City of Phoenix
PLANNING AND DEVELOPMENT DEPARTMENT

Staff Report: Z-65-20-6
June 28, 2021

[PUD](#) (3.23 acres)

Multifamily residential development

Broadstone on 7th Z65-20N

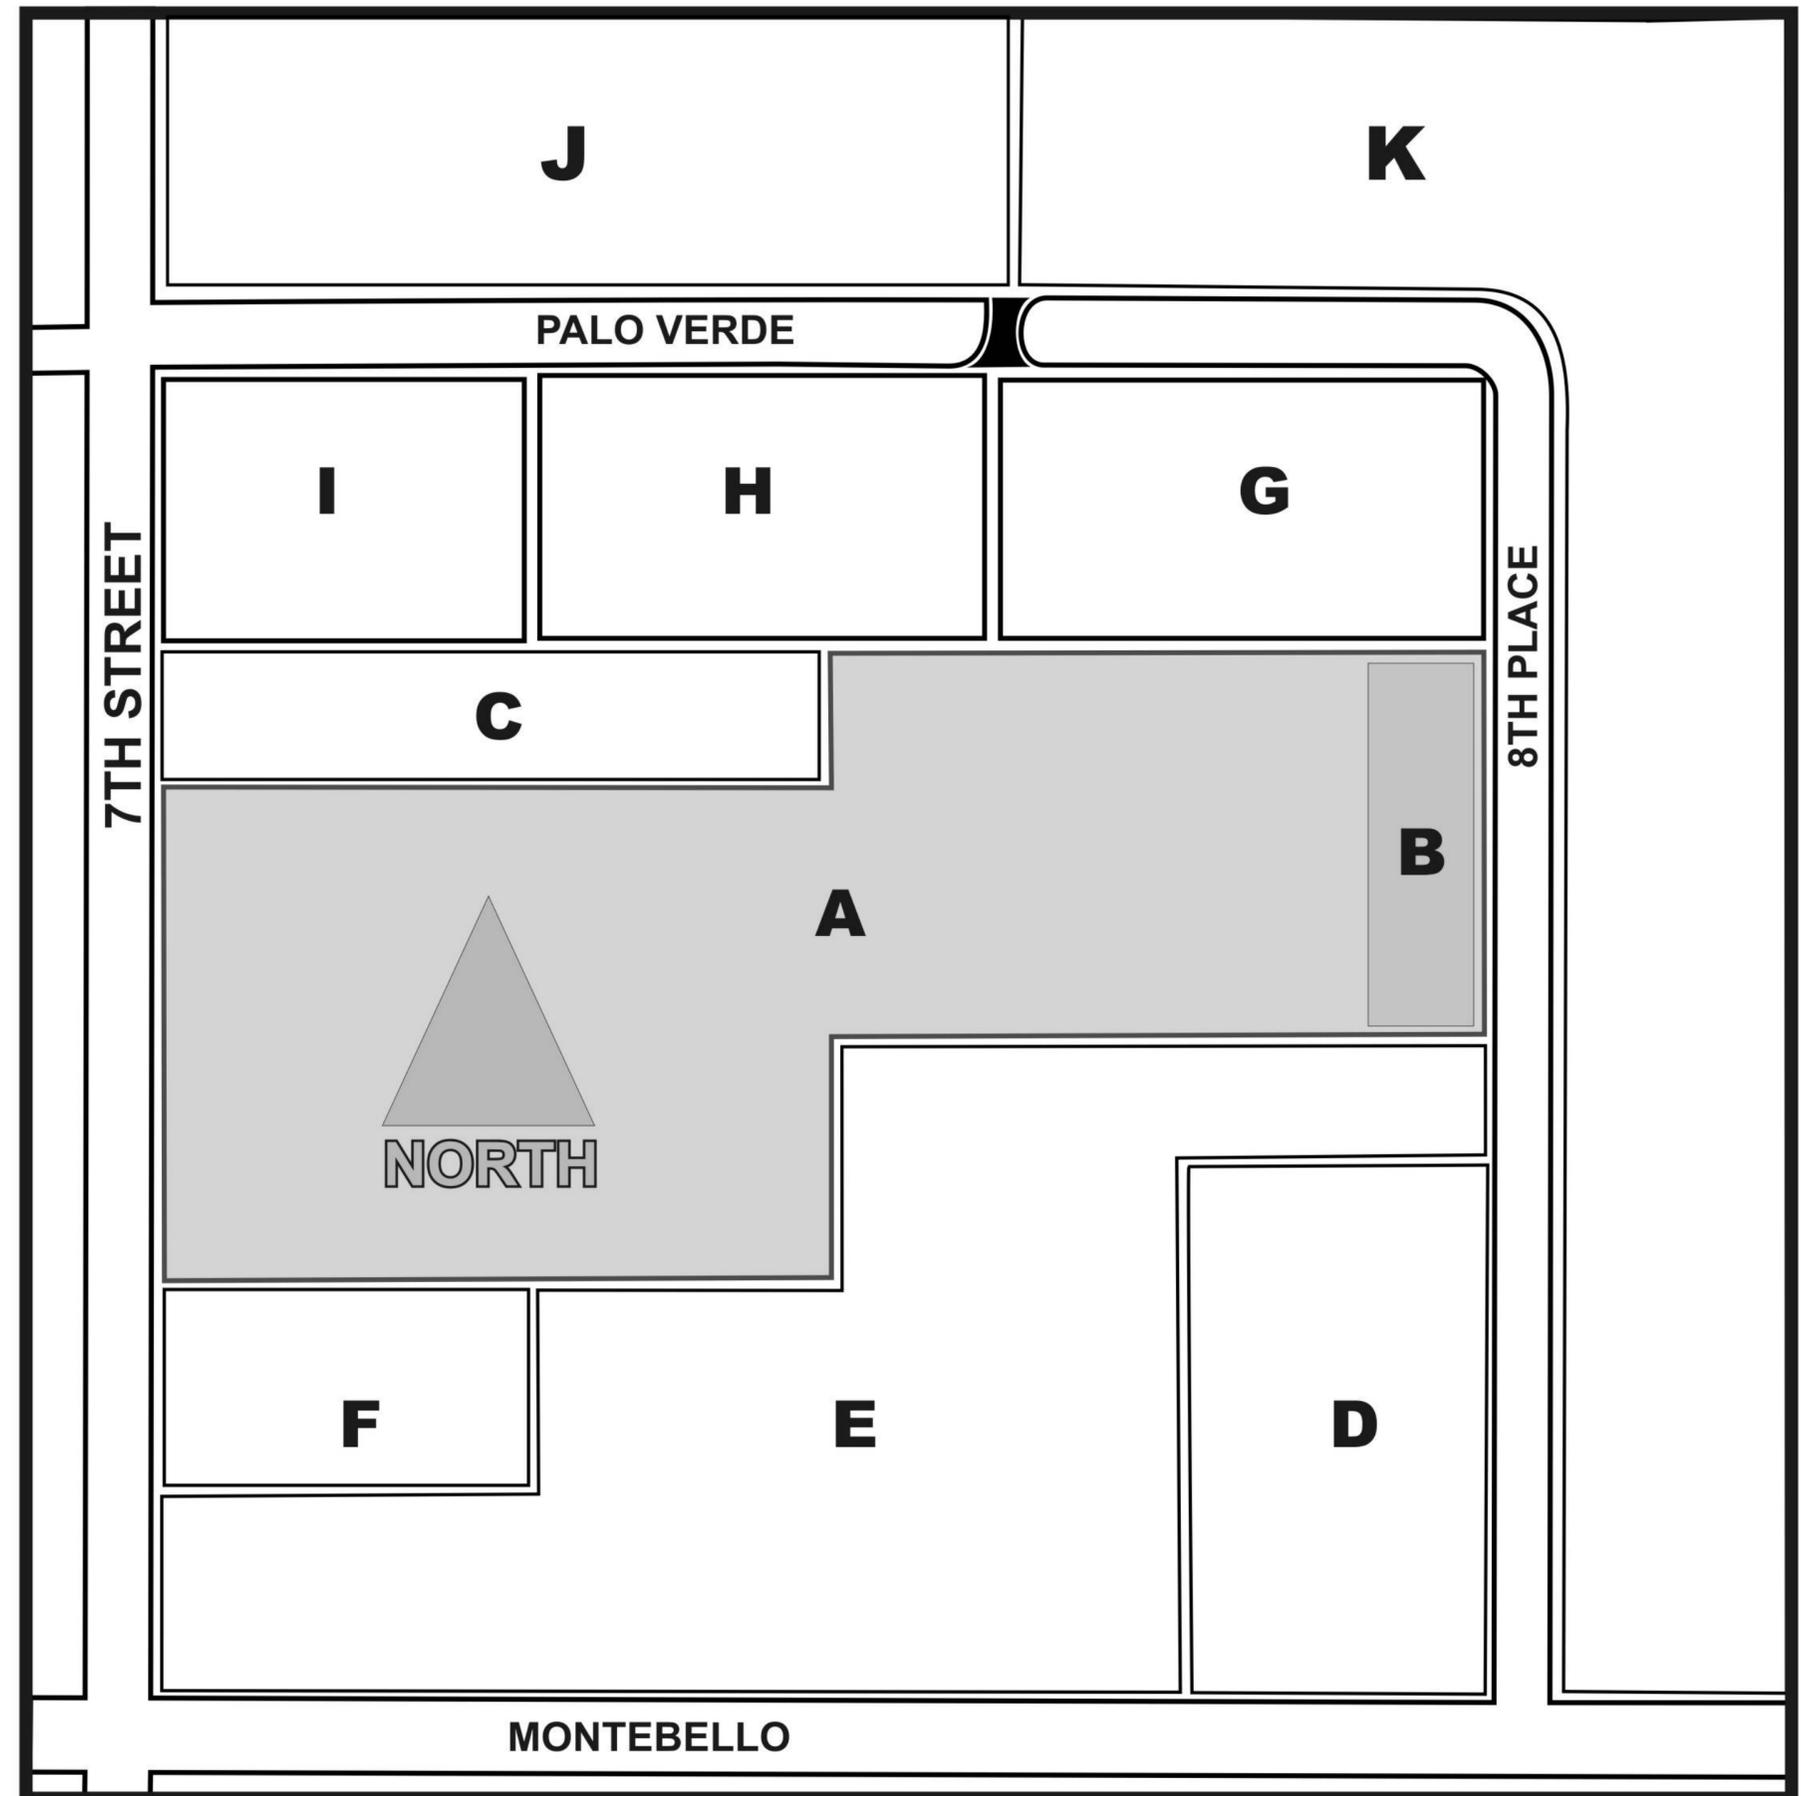
Parcel A - reduce to 4 story - increase parking to a minimum of 1.7 spaces per bedroom. Phoenix is noted as one of the cities experiencing a dramatic increase in 'roomates' sharing living space. Considering the area and rents, any parking must address this change.

Parcel B - of major concern. At the least it needs to be turned so as to allow access from within the project. No access to 8th Place at all. Allowing construction as shown would remove ALL remaining parking on the west curb on 8th Place. This is an old residential city street which is already too narrow by a minimum of 15ft.

Parcel C - I was told it has been added to the project. Unknown. If added, appears to have no effect if all other concerns are addressed.

Additional: Make Palo Verde 'not a through street' by planting a garden/barrier on the street at the wall of the apartments to the North. This retains full access to all commercial businesses on both sides of Palo Verde and the residential nature of 8th Place is also retained.
